## **CITY OF CROSSLAKE**

### **PLANNING COMMISSION/BOARD OF ADJUSTMENT**

**Site Location:** 33584 Lake Street, Crosslake, MN 56442 on Crosslake-GD

## STAFF REPORT

# CERTIFICATE OF SURVEY

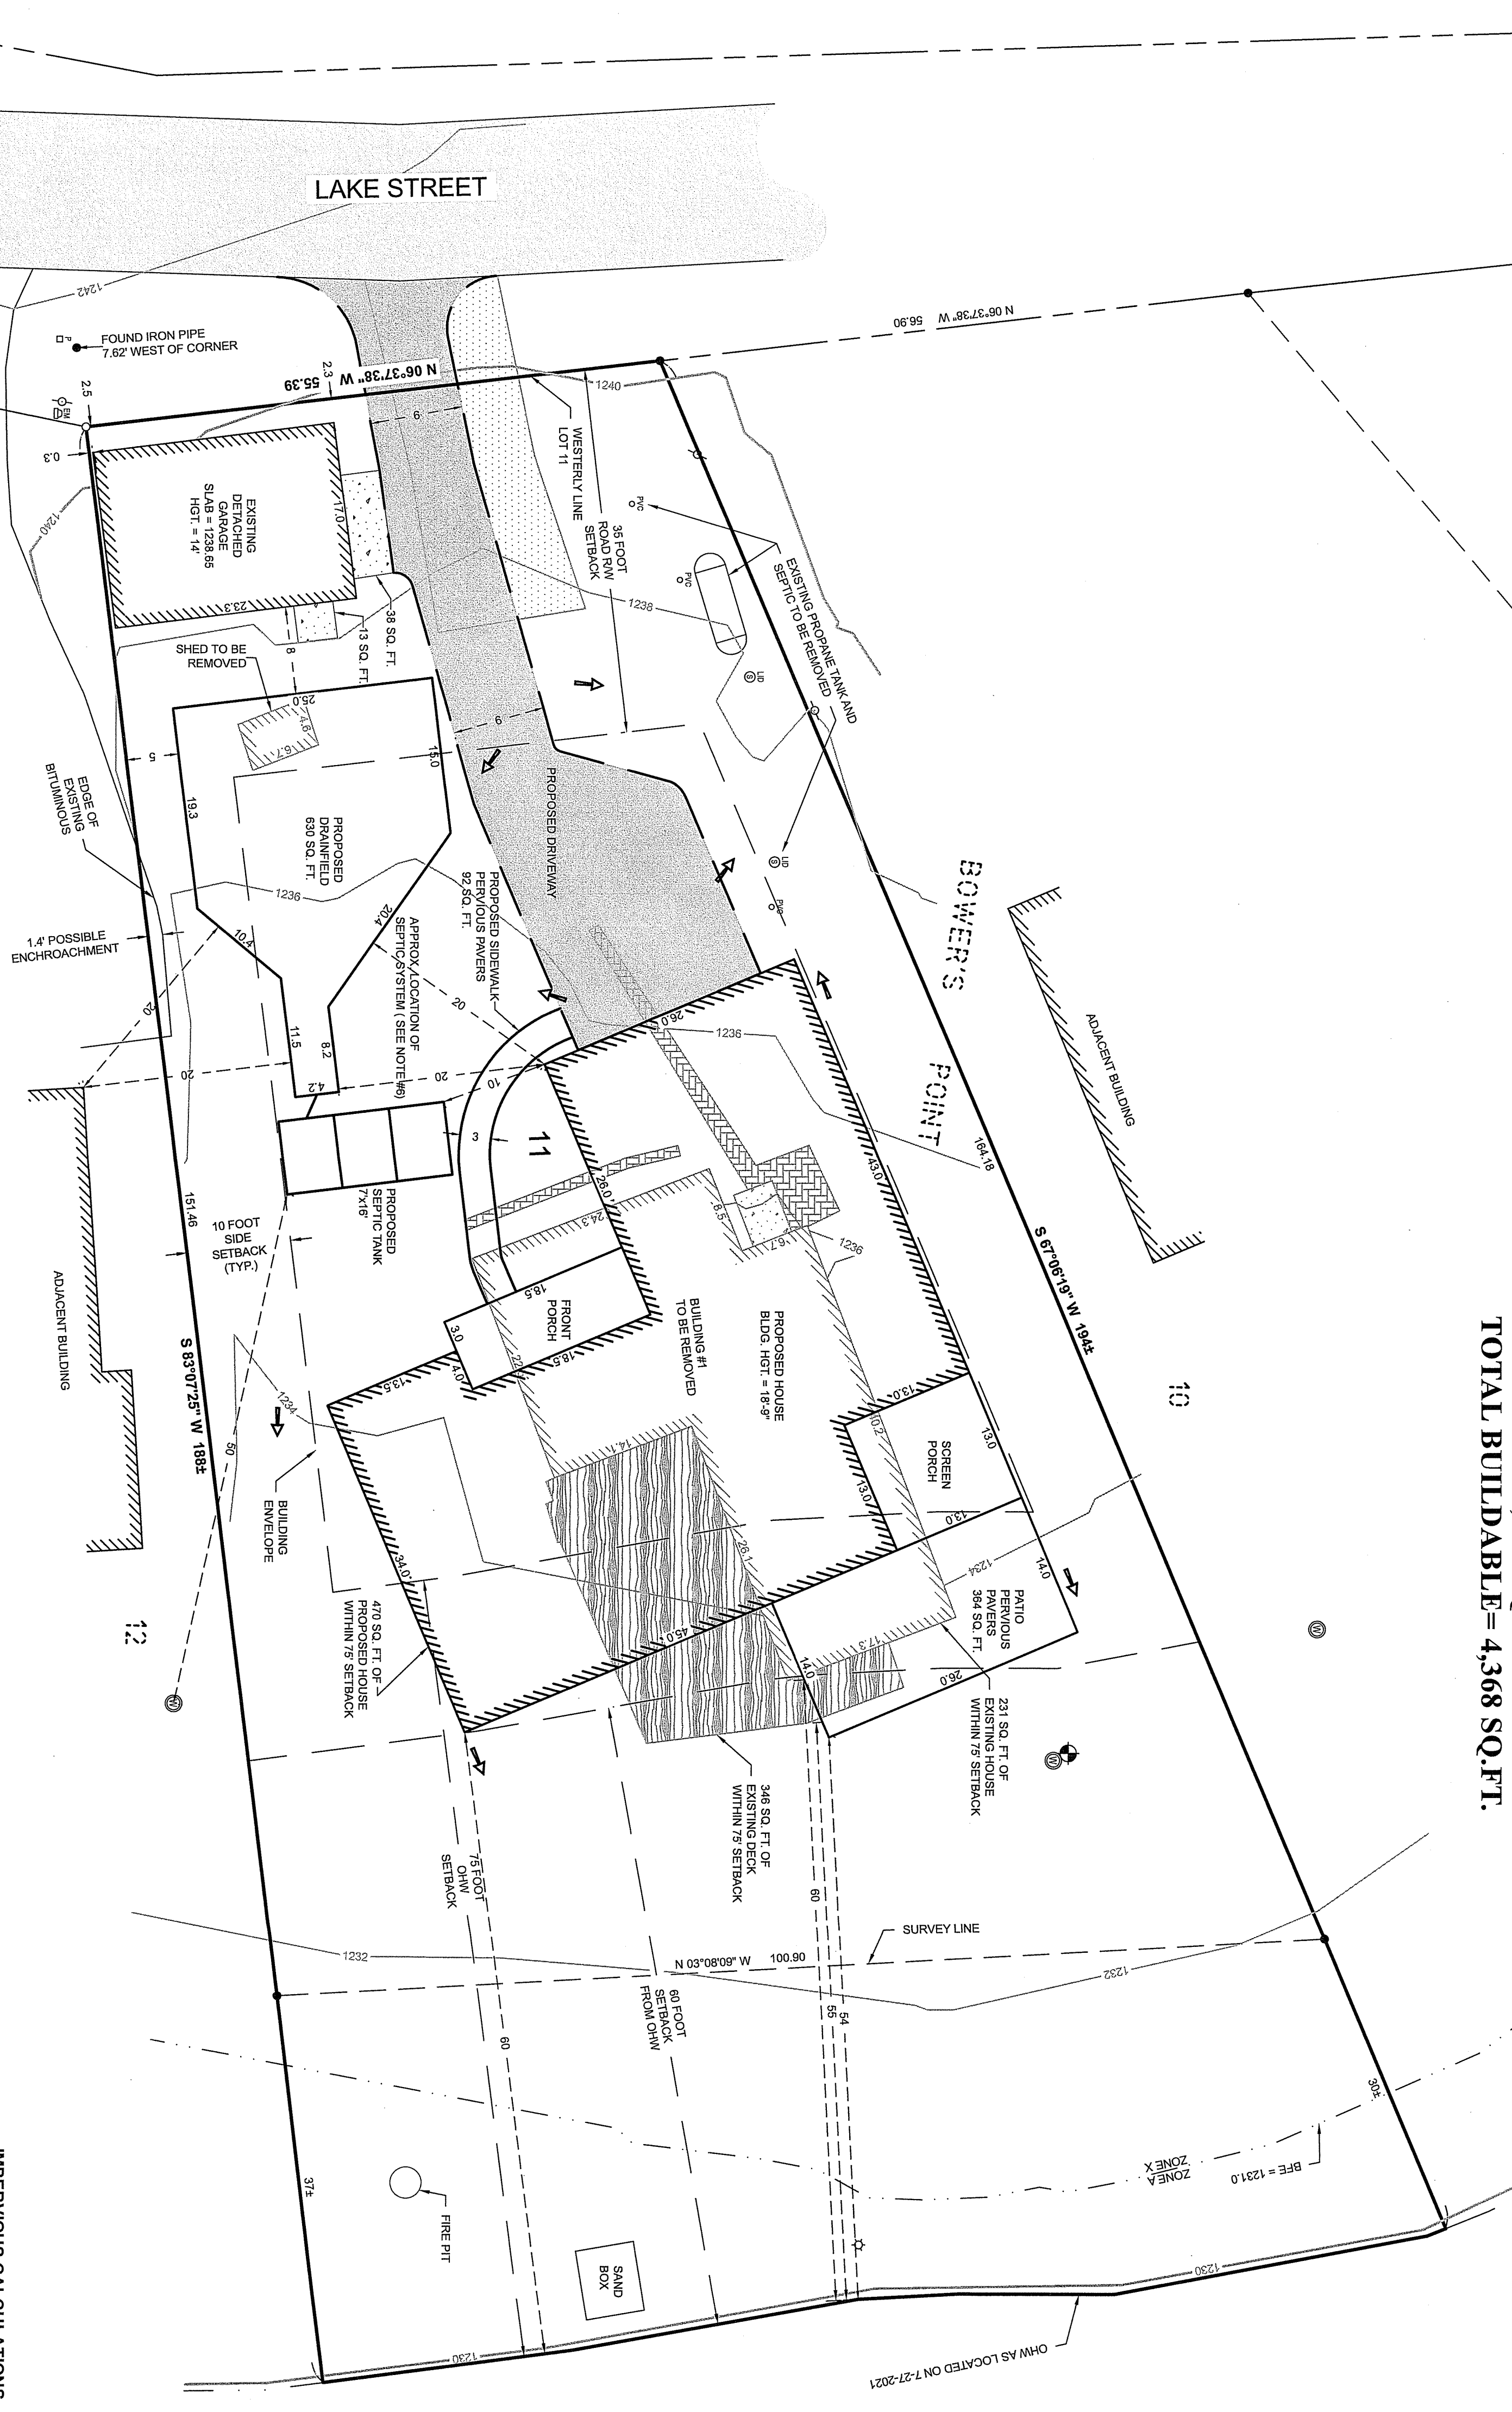
Brewster – The stormwater plan needs more grading and computation detail to show the plan is feasible. I'd request stormwater area grading/contour detail that shows adequate stormwater volume will be provided.

Note that the normal reservoir pool elevation is 1229.57. That means no stormwater area can have a bottom elevation lower than 1232.57 to provide 3' separation to assumed groundwater elevation for storage/infiltration area. If applicant has soil boring that shows groundwater elevation is lower than normal pool, we would consider that for setting storage area bottom limits.

Based on contour information provided, Stormwater areas 1, 2, and 3 locations seem to be unacceptable to provide 3' separation required for an infiltration area.

Stormwater areas 5 and 6 are adjacent to proposed pressure bed. Pressure bed system designer notes direct that roof water and driveway water should be diverted away from the pressure bed. We recommend they remove those areas and divert water away to stormwater storage area 4 and the north side of driveway.

The new pressure bed will occupy the only drainfield space and no secondary site has been identified according to the designer's notes.

In response to the comment about stormwater storage not allowing 3’ of separation from the groundwater elevation: We plan for the slab-on-grade foundation to be at a height of around 1237’ and gently descending towards the parcel’s current elevation at the SIZ1 boundary. Additionally if needed, we will shrink the portion of the stormwater storage areas nearest the lake and increase their depth near the building to maintain the same volume. These changes will ensure the 3’ of separation that’s required.

In response to the comment about stormwater storage being adjacent to the septic drainfield: If the final placement of the septic does not allow for storage in those areas, we will plan to slope the driveway and use gutters on the existing garage to divert water to the north of the driveway as suggested.

Brewster  
33584 Lake St  
14310672

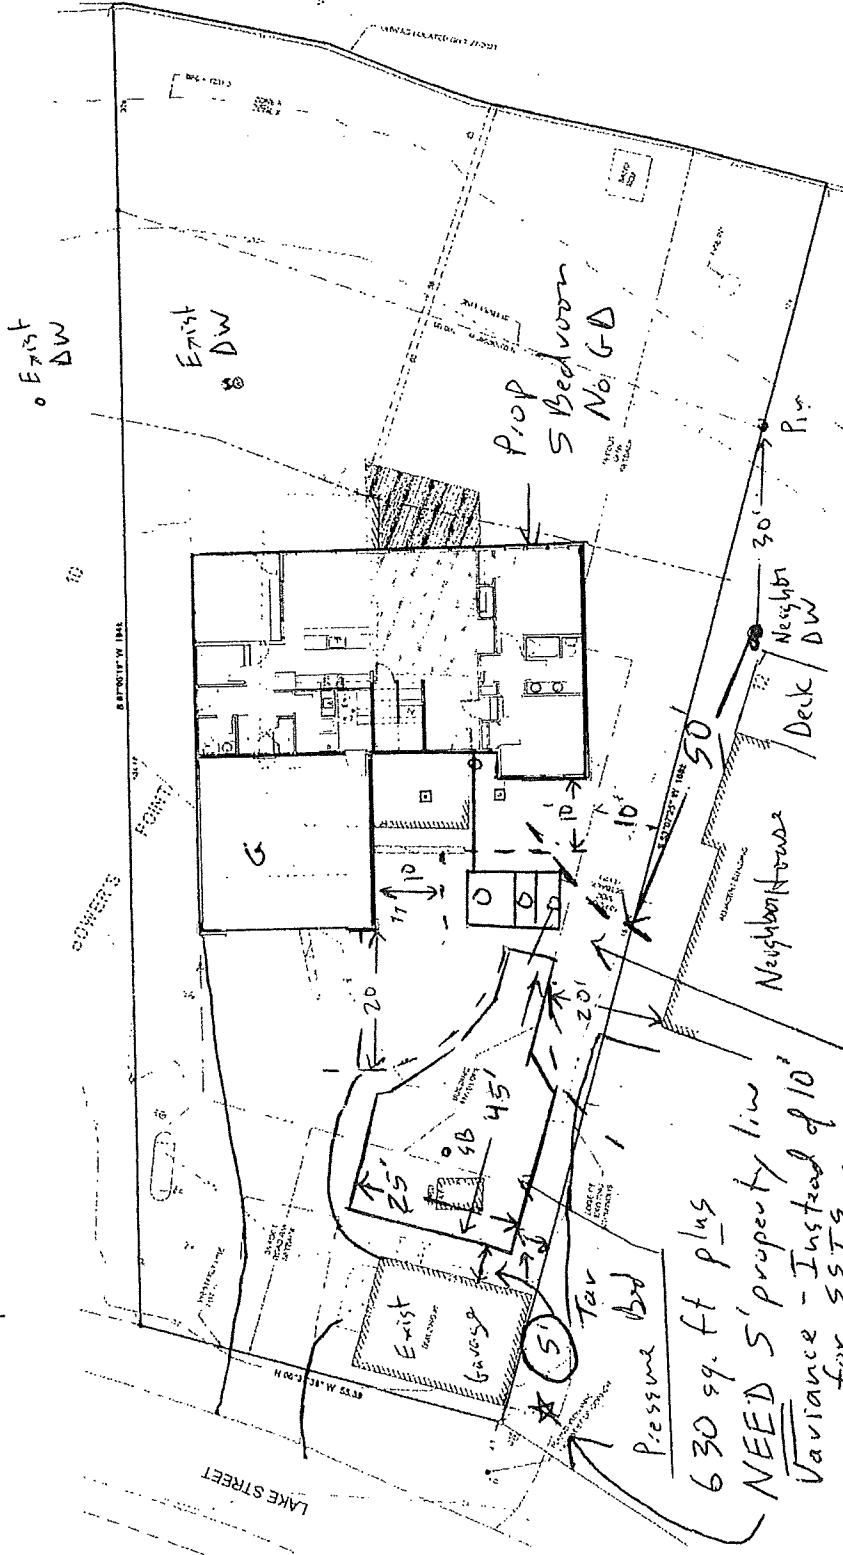
630 sq. ft plus  
NEED 5' property line  
Variance - Instead of 10'  
for SST's  
- Gutter garage roof  
water away,  
- Divert driveway  
surface water away.
